### APPEAL SUMMARY

**Appeal ID:** 15949

**Project Address:** 3636 NE 115th Ave

**Appeal Type:** Plumbing

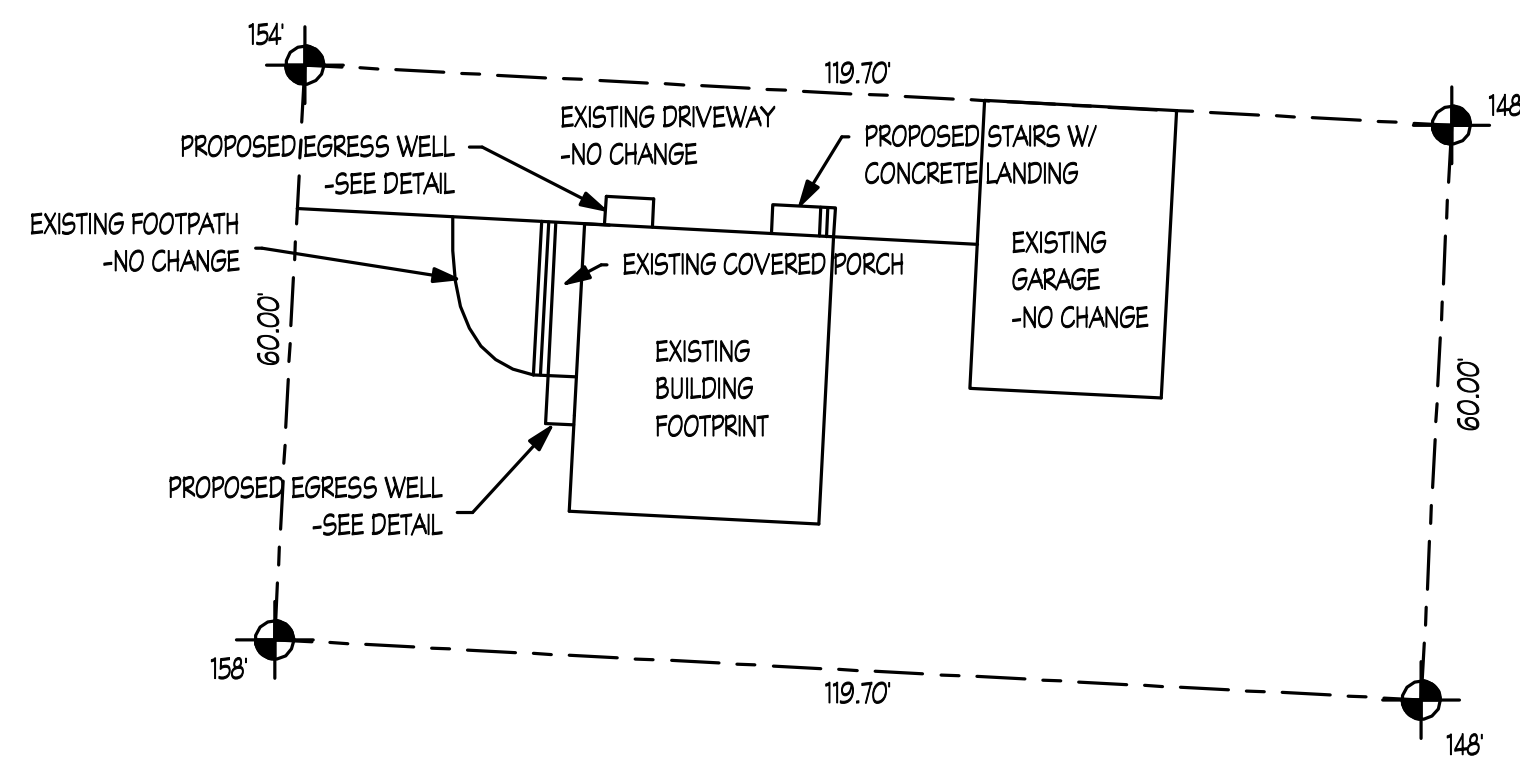
**Requires** Approval of the pump installed in order to have a bathroom in the basement

**Proposed Design** Addition of a bathroom and laundry room in our basement so we added an ejector pump. We put drain lines made of ABS in to the floor for the new shower, toilet, sink, and washer.

**Reason for alternative** Our basement floor is 30 inches lower then our main sewer line where it leaves our house as seen in the enclosed pictures. We have to have a pump to lift the waste water up to the sewer line. At that point it can gravity drain to the city main where according to Portland maps we have a connection depth of 8ft.

The appeal board has determined that an appeal is not required. Appellant may contact Jim Bechtel (503-823-7386) for details.
